**TOWN OF MOUNTAIN VILLAGE
DESIGN REVIEW BOARD
REGULAR MEETING
THURSDAY, JANUARY 7, 2016 10:00 AM
2nd FLOOR CONFERENCE ROOM, MOUNTAIN VILLAGE TOWN HALL
455 MOUNTAIN VILLAGE BLVD, MOUNTAIN VILLAGE, COLORADO
AGENDA
REVISED**

TO: Design Review Board
FROM: Dave Bangert, Town Forester
FOR: Meeting of January 7, 2016
DATE: December 22, 2015
RE: Consideration of a Design Review application for a new single-family dwelling on Lot 421

**RESOLUTION OF THE DESIGN REVIEW BOARD
OF MOUNTAIN VILLAGE, COLORADO, AUTHORIZING AND APPROVING THE DESIGN
REVIEW PROCESS FOR LOT 421**

LOT 421
MOUNTAIN VILLAGE
DRB GRADING PLAN

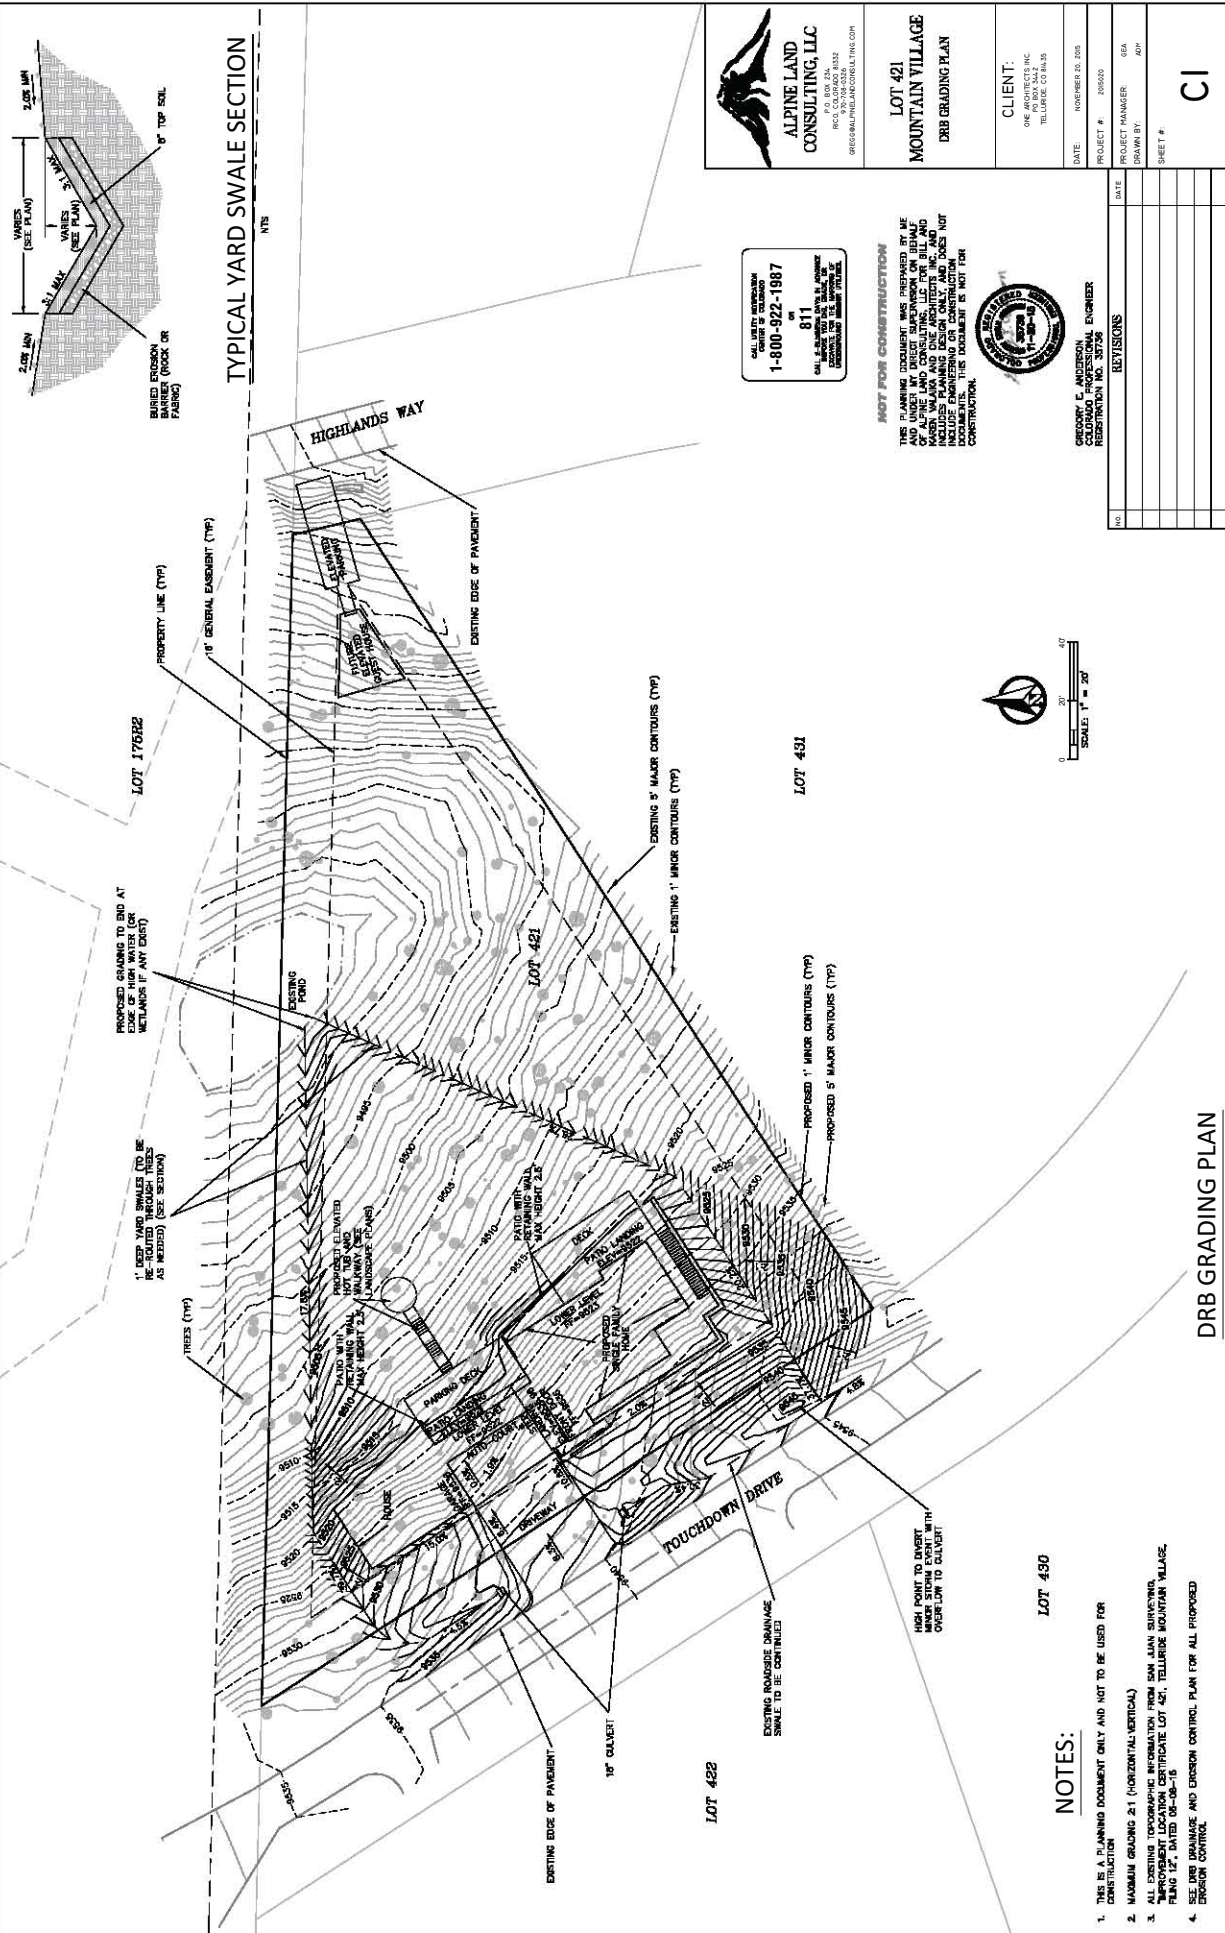
The applicant has provided a grading and drainage plan prepared by Alpine Land Consulting, LLC for the proposed development. Positive drainage away from the structure has been created. The plan includes two drainage swales emanating from the north and south side of the structure. The northern swale goes into the General Easement and both swales terminate at the pond/wet area. An 18” culvert is being shown under the driveway at the road.

A2.1
 site + utility plan

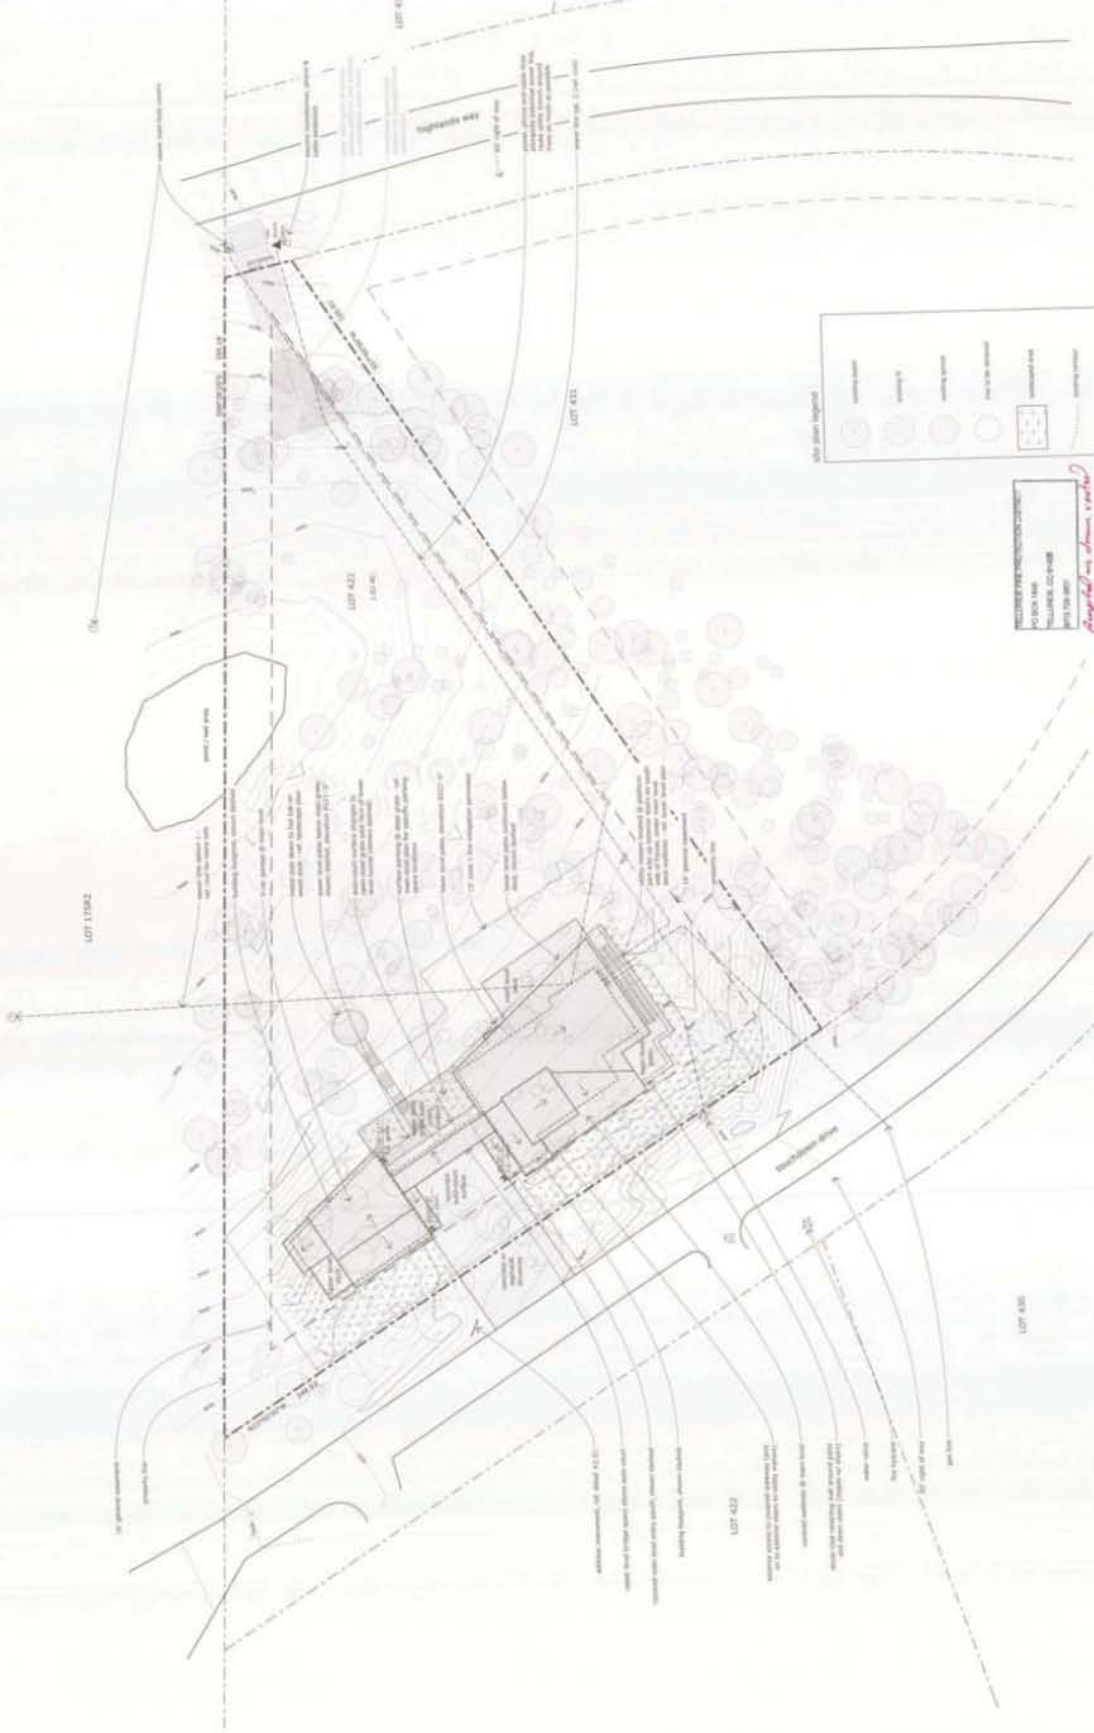
There are two (2) options shown for the sanitary sewer alignment. Option one shows the sewer alignment crossing Lot 175R2 to reach the 30' sanitary sewer easement. This option will require an easement agreement between the owners of Lot 421 and 175R2. The second option for the sewer line runs to the east side of the lot and picks up the sewer easement without crossing Lot 175R2. This will require a pumping station in the middle of the lot. Public Works will review the final layout of the utility plan and commented that the developer is responsible to determine the actual location of the existing utilities.

The applicant is proposing a road cut/driveway width of 33' with slopes of 8.3% to 10.8%. The city code states:

Though Telluride Fire District staff supports the proposed driveway width, Public Works staff is not in favor of the 33' wide driveway cut because it complicates snow plowing of the road. Staff recommends that the DRB require the applicant to revise the plans to show a 12' wide paved surface in the RROW that expands to 33' wide auto court at the lot line. Due to the steepness of the driveway the DRB may require a snow melt system be incorporated into the driveway design.

4. Prior to issuance of a building permit, applicant shall obtain an easement across Lot 175R2 if the applicant elects to proceed with sewer line alignment (option one) which crosses Lot 175R2. Alternatively applicant shall use sewer line alignment (option two).

8. There will be a snow melt requirement for the driveway due to the 8.3% to 10.8% slope with any snowmelt in excess of 1000 sq. ft. requiring an energy offset payment to the Town.

A2.2
 construction
 mitigation plan
 copyright 2015 - planed 11/24/15

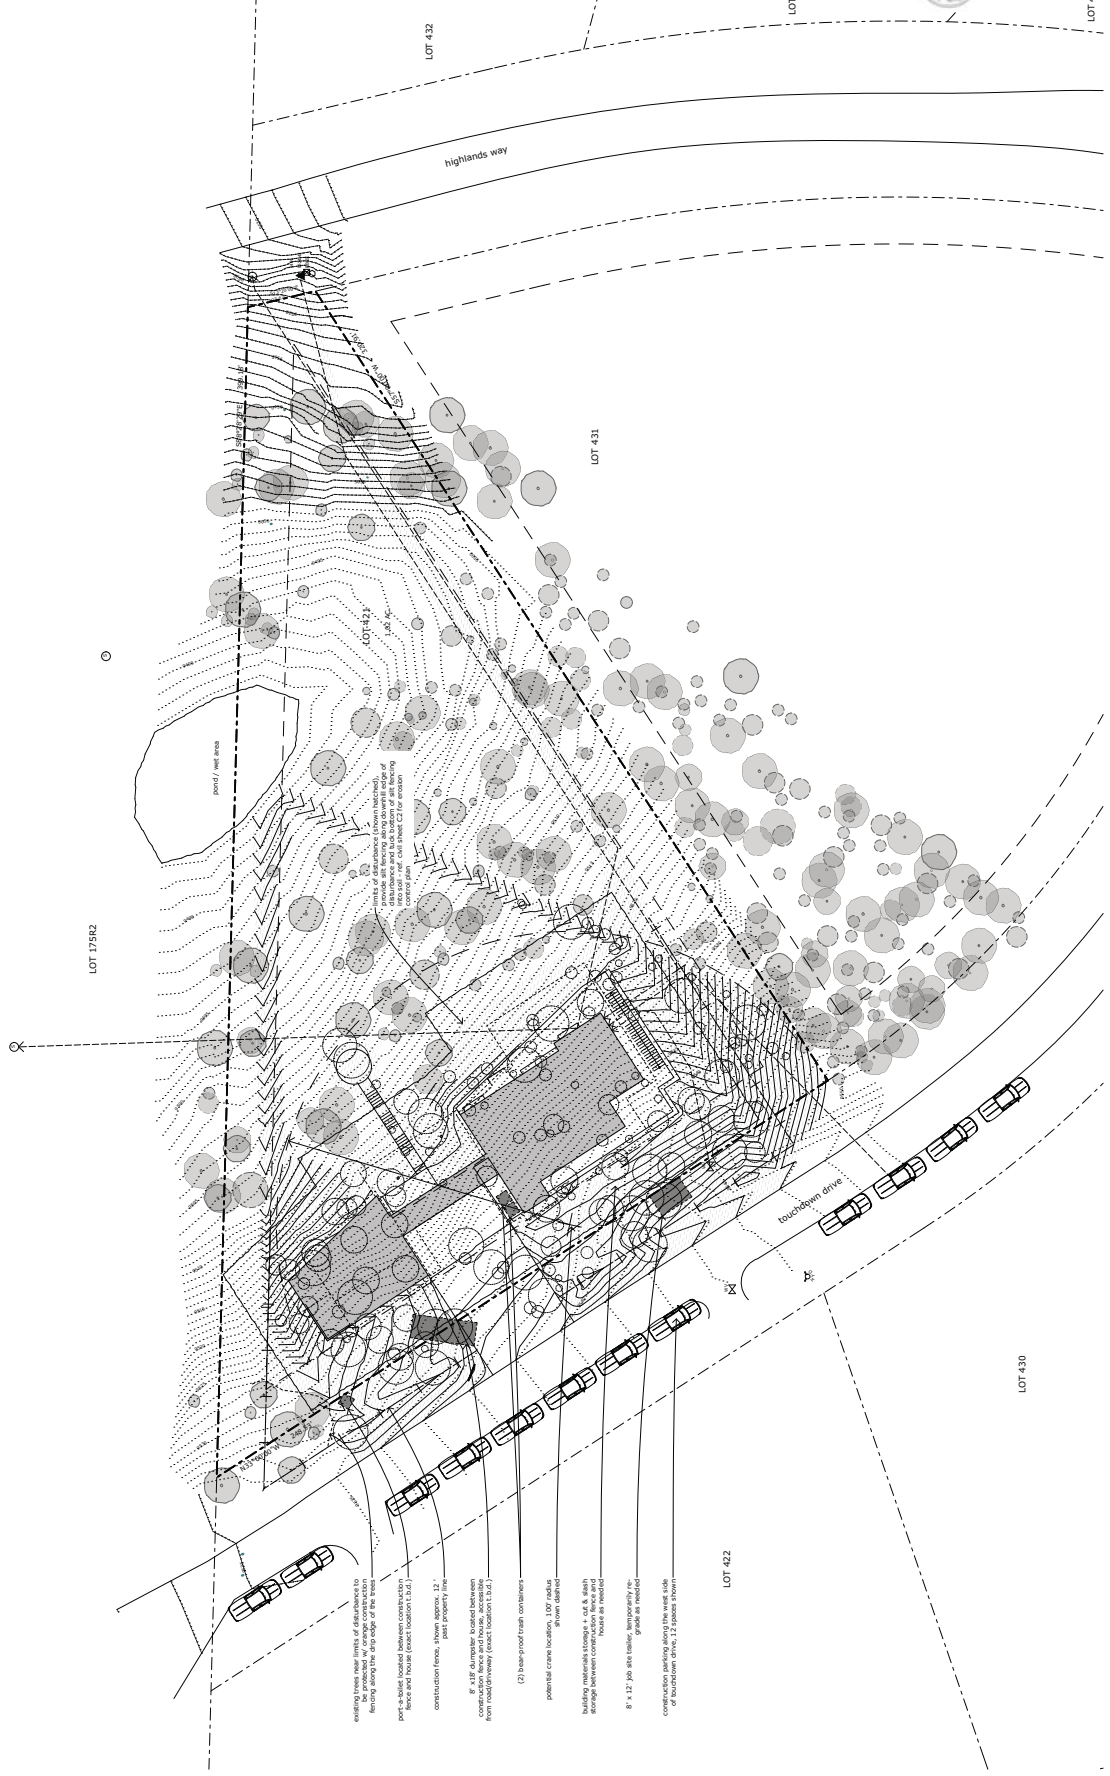
The applicant is proposing to use the western General Easement and the Touchdown Dr. RROW for construction staging. The staging plan shows parking for 12 spots along the west side of Touchdown Drive. The MV Public Works Department does not support parking along the west side of Touchdown Dr. due to plowing concerns. This will require specific approval from the DRB for the use of the GE and license approval from the MV Town Council for temporary use of the RROW for construction staging.

1. Prior to issuance of a building permit the applicant will seek the approval of the Mountain Village Town Council for temporary construction staging in the Touchdown Drive RROW and enter into a license agreement with the Town for use of the RROW for construction staging.

A2.4
 Irrigation plan

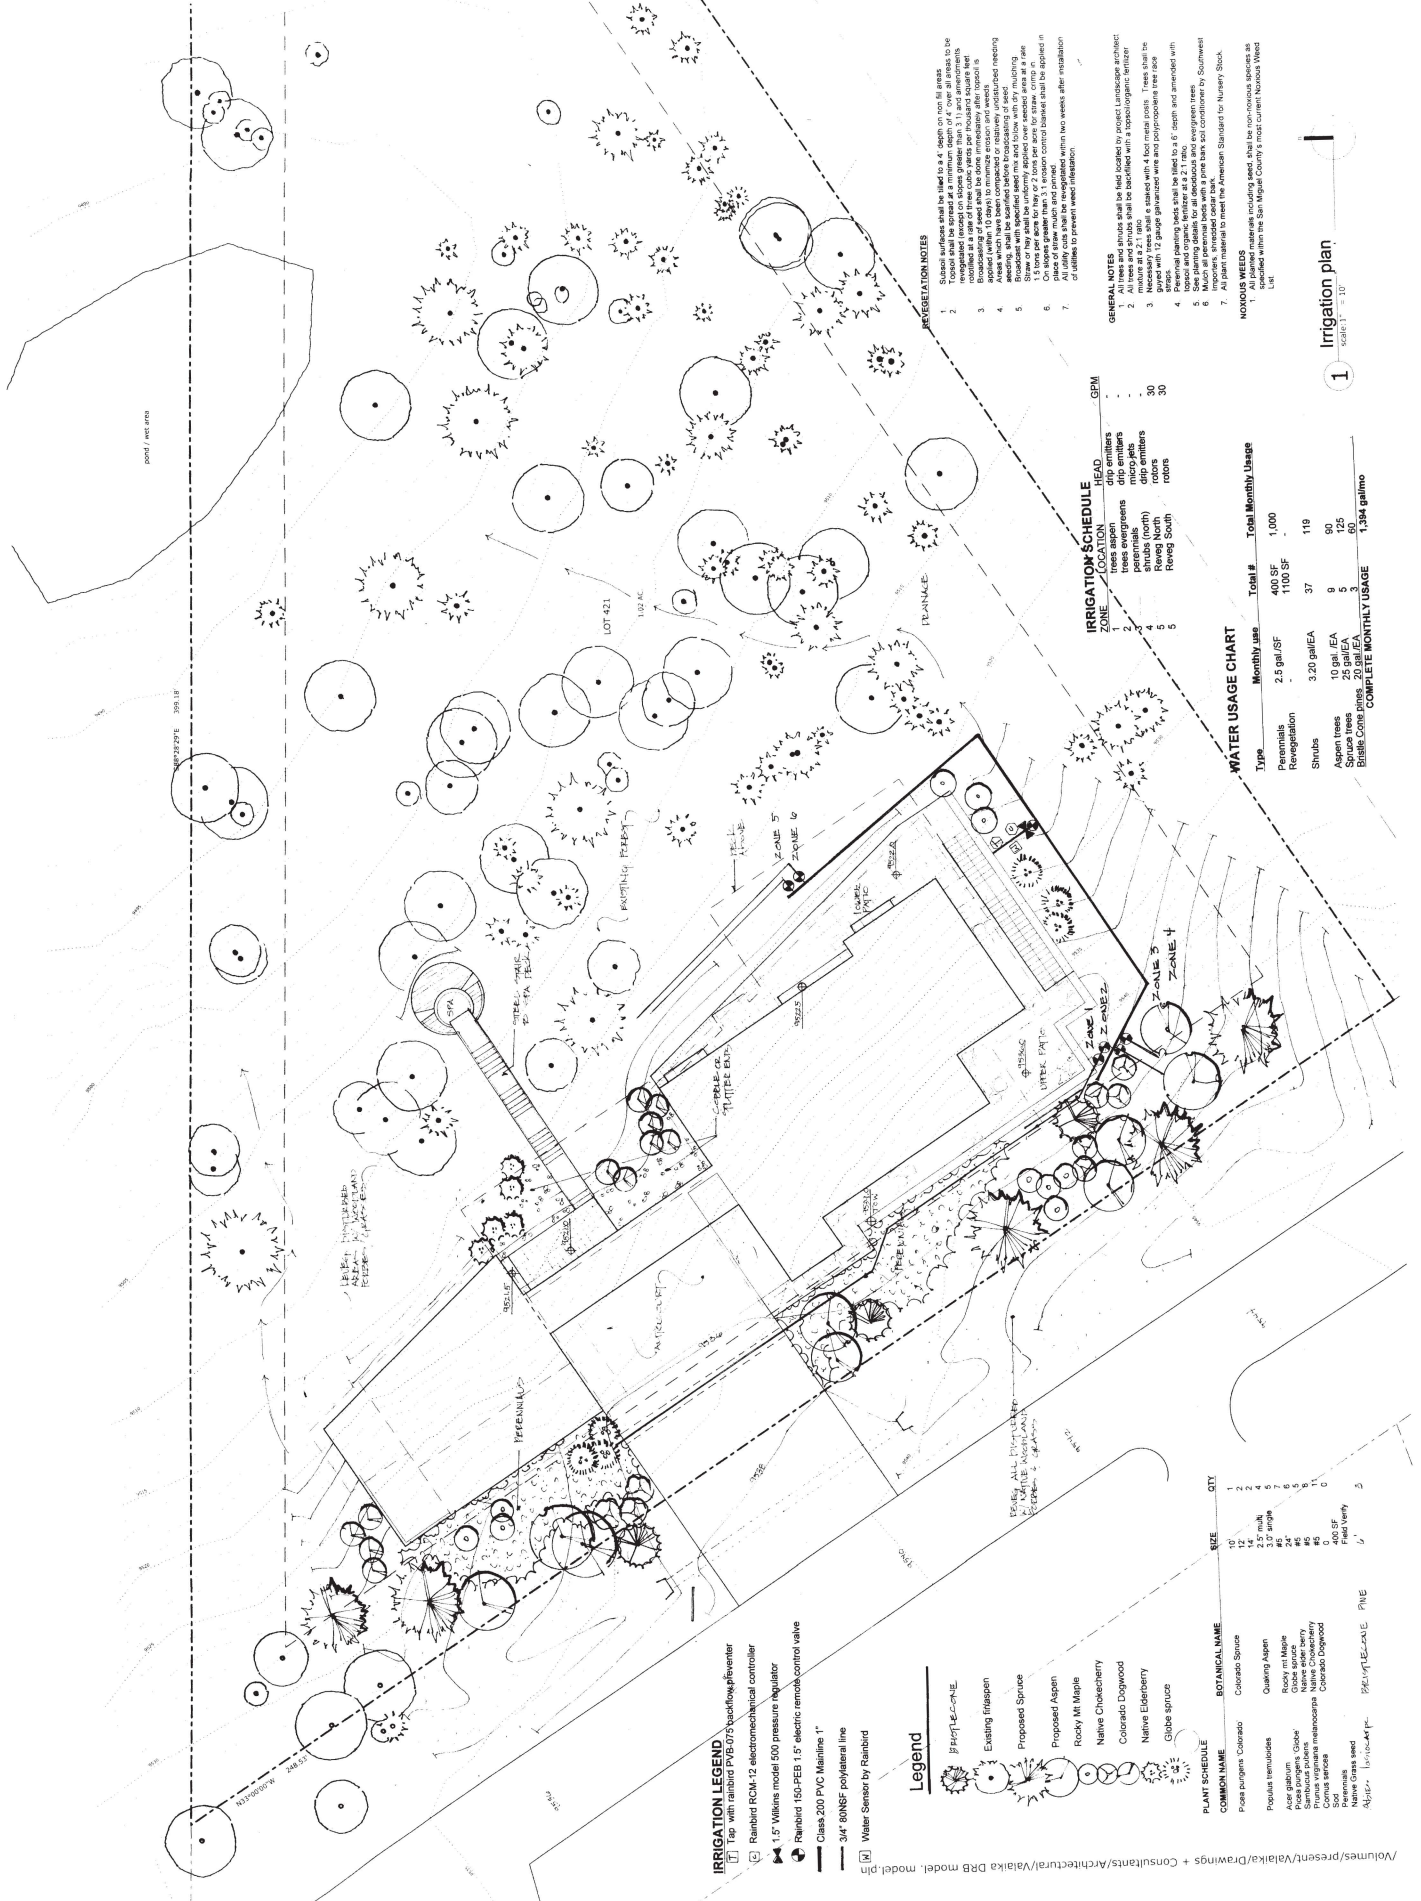
An irrigation plan has been submitted and is in compliance with Table 5-3, Irrigation System Design. A rain shut-off device is called out in the plans as well as a backflow prevention device.
